# SITE PLAN REVIEW AND APPEARANCE BOARD STAFF REPORT

Meeting: December 12, 2018 | File No.: 2018-200-SPF—SPR-CL5 | Application Type: Class 5 Site Plan – Coastal Business Park

Sheet:  
**LP-1**  
Of: Two

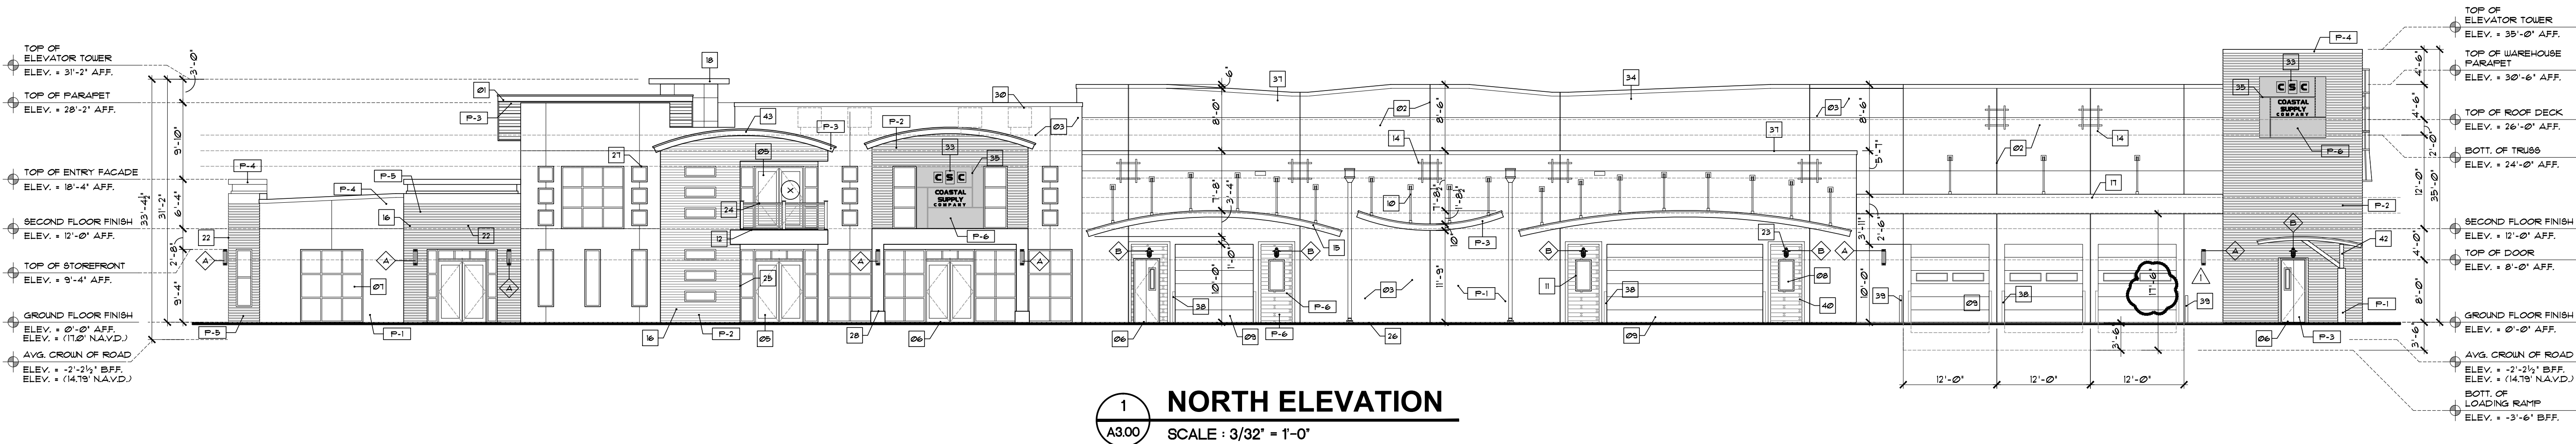
3. That the applicant updates the landscape plans showing all the utility easements prior to site plan certification.
4. That the applicant updates the landscape plans to show existing trees to remain or be removed prior to site plan certification.

- ✓ As shown on page LP-1, the applicant is providing at least 135-sf of planting area in landscape islands and bulb-outs at the at the end of every group of parking spaces. Each group has less than 13 parking spaces. Therefore, the applicant has met the minimum requirement for parking islands.

- ✓ As shown on page LP-1, the applicant is providing 4.5' foot tall "Yew Podocarpus" shrubs for landscape screening around the dumpster enclosures and generator slab. The mechanical equipment is shown on page A1.00 on the roof and be screened by a parapet wall. Thus, this requirement has been met.

1  
A3.00  
NORTH ELEVATION  
SCALE: 3/32" = 1'-0"

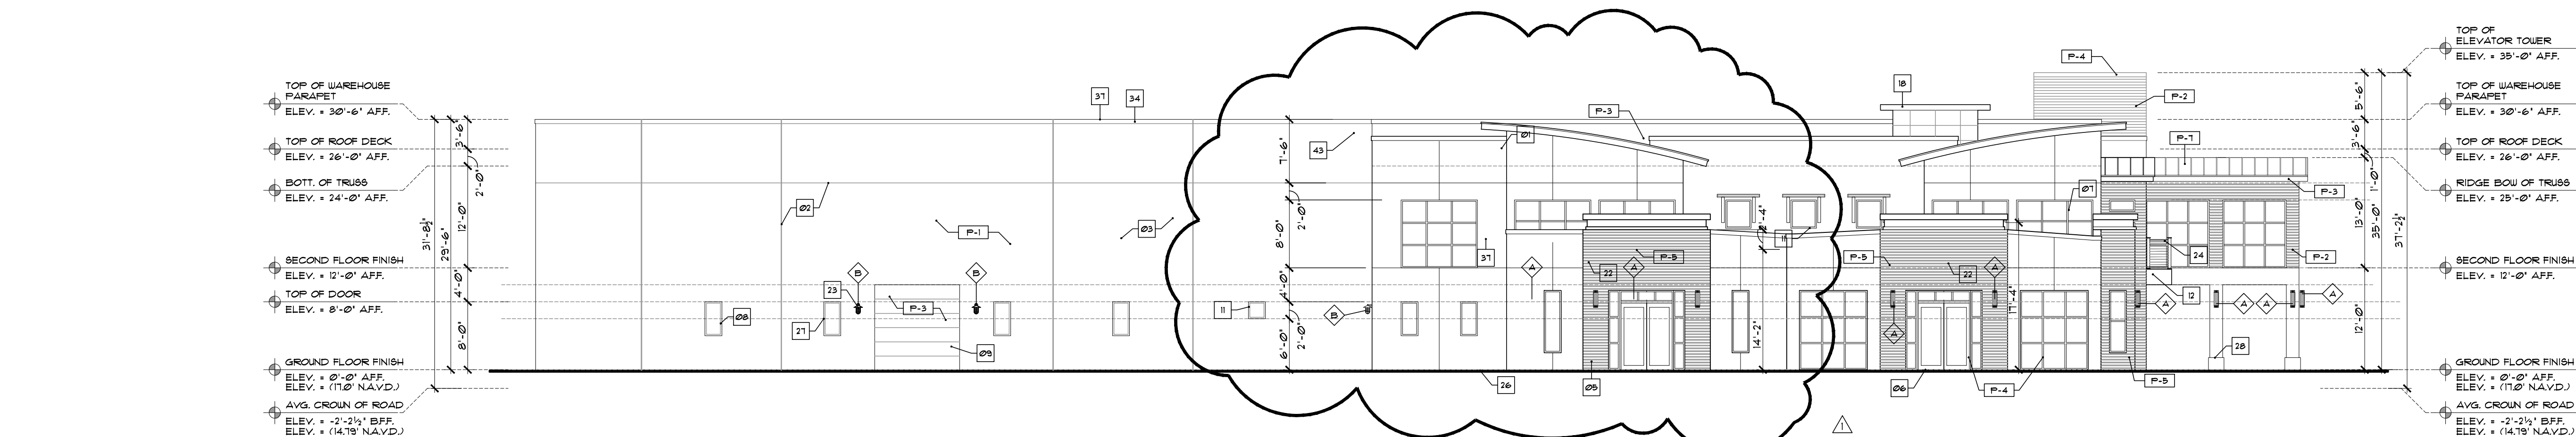
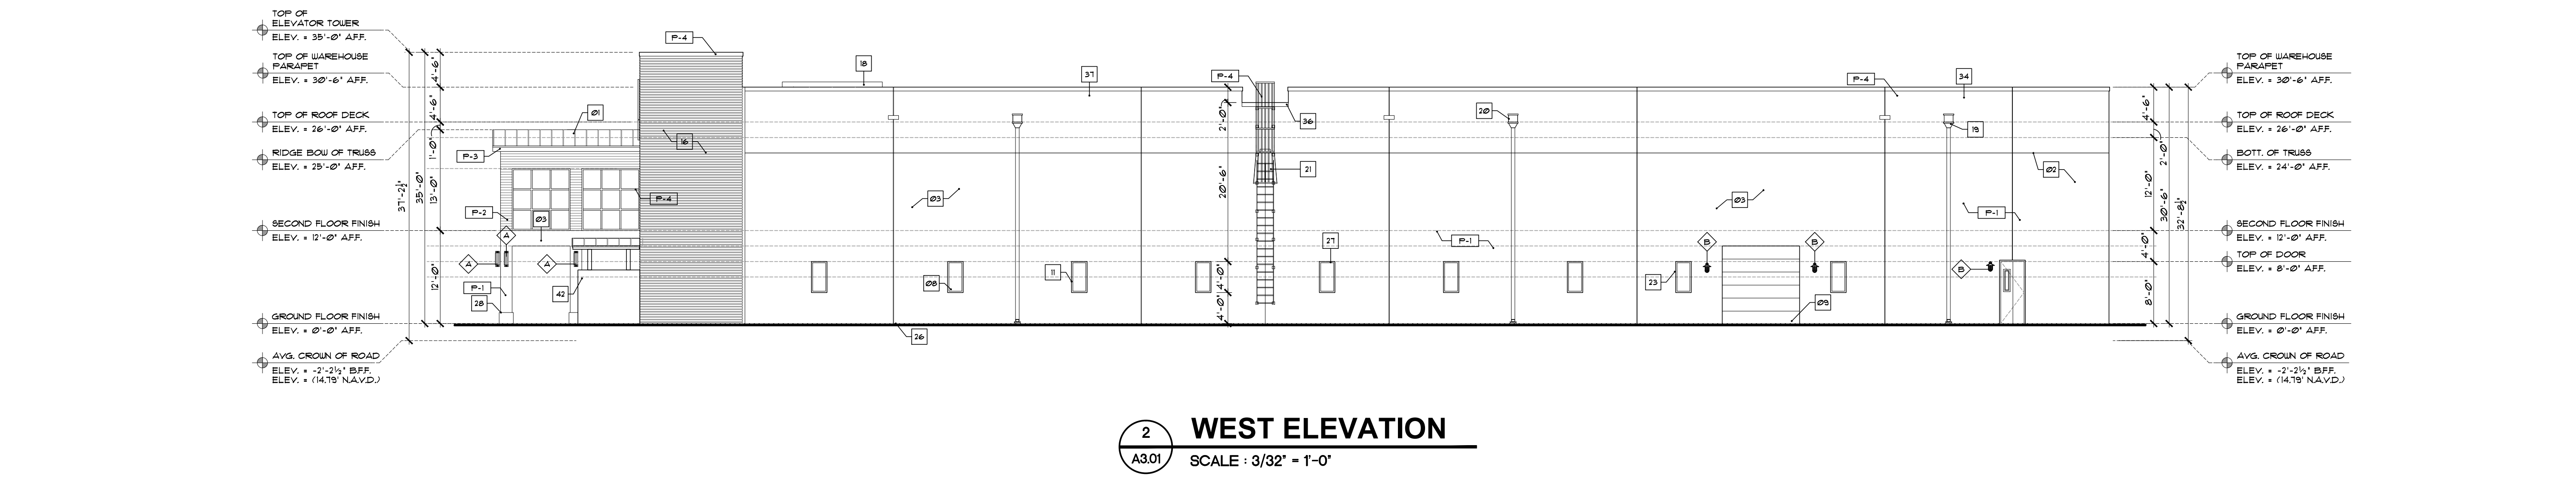
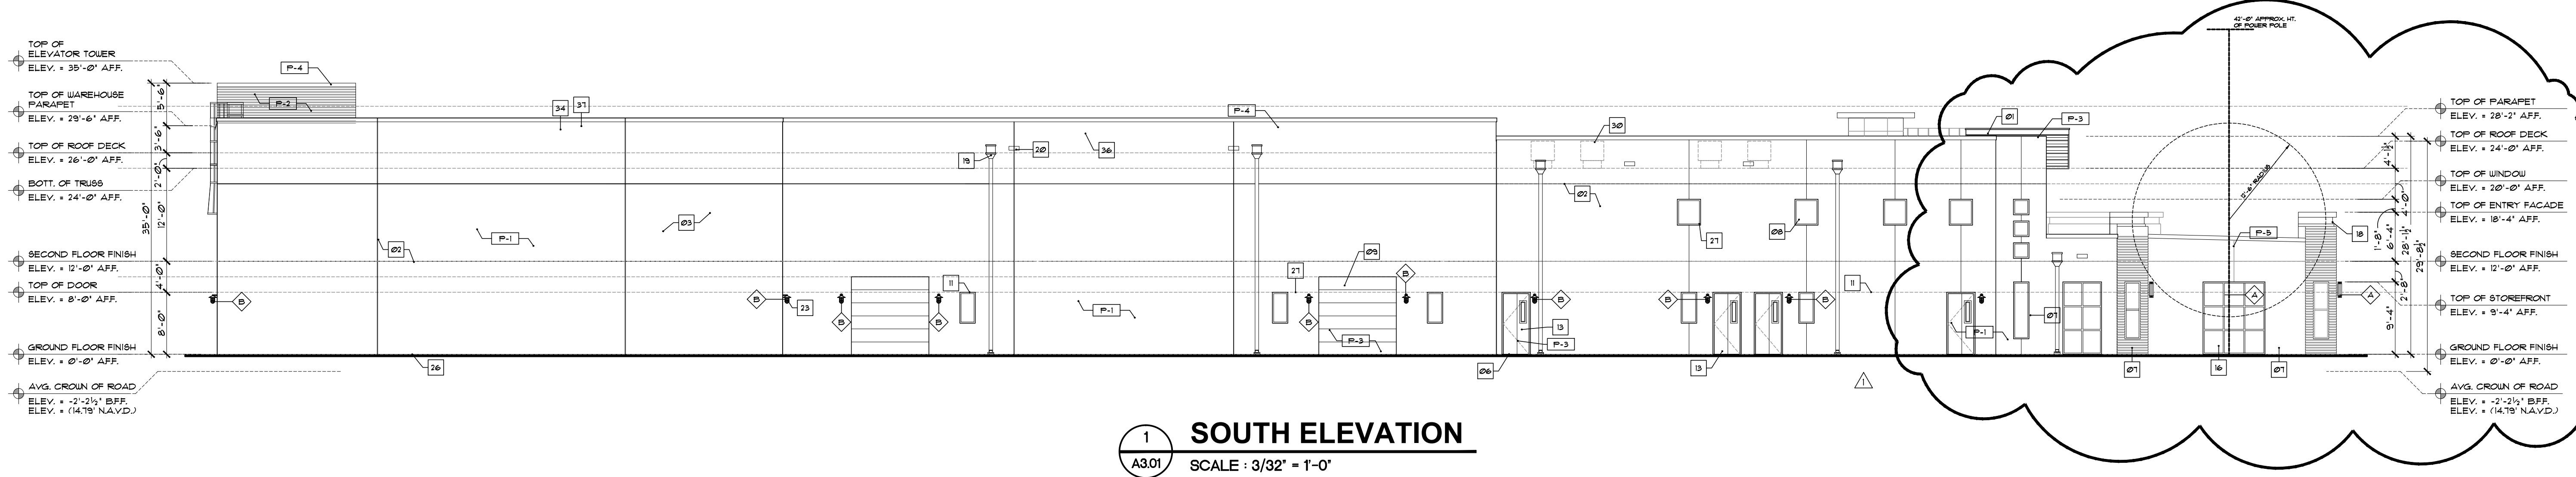
- ✓ The proposed 28,493-sf warehouse building with manufacturing, showroom and tenant office space is a compatible use with the MIC-Mixed Industrial and Commercial zoning district. The building has been designed with modern architectural aesthetics. All facades visible to public or adjacent properties have been designed to create a harmonious appearance. The materials used, express their function clearly and do not appear to conflict with the rest of the building elements. The façades are composed of stucco with extruded reveals and scoring, kynar coated metal awnings and canopies, balconies with powder coated handrails, an varying elevations and wall mounted lighting. The proposed colors for the main building are “Arcasia White”, the tower and entry feature is “Red Wood” solid stain, the fascia, canopy and balcony is “Kendal Charcoal,” the storefront doors and windows is “ Brilliant White,” the Tenant Entry feature is “Hidden Valley,” the signage is “Hidden Valley,” and the standing seam roofs are “Sandstone.” The storefront doors and windows, and overhead doors proposed are made of impact resistant material with kynar color frames.

- ✓ Staff believes that the proposed building expresses “honest design construction” as it uses weather resistant materials such as impact resistant storefront doors and windows and overhead doors, and sustainable building practices energy efficiency lighting, water conserving plumbing fixtures and irrigation, and Florida Friendly and native landscaping. Therefore, this requirement has been met.

- ✓ Staff believes that the proposed building shows “proper design concepts” utilizing modern architectural design aesthetics, compatible colors with surrounding facades and similar scale with adjacent buildings, thus this requirement has been met.

- Pursuant to LDR Section 4.6.18 (E)(1), **Structure Conformity**, the plan or the proposed structure is in conformity with good taste, good design, and in general, contributes to the image of the City as a place of beauty, spaciousness, harmony, taste, fitness, broad vistas, and high quality.
  - ✓ Staff recommends that the proposed structure meets the City’s intent for “good design” as the building is

designed with modern architectural aesthetic features such as angulated facades with varying heights and depths, scored stucco reveals, balconies with powder coated handrails, and kynar colored metal awnings and canopies. Furthermore, staff recommends that the overall design of the site is similar in scale and look with the adjacent structures and properties; thus, meeting this requirement.
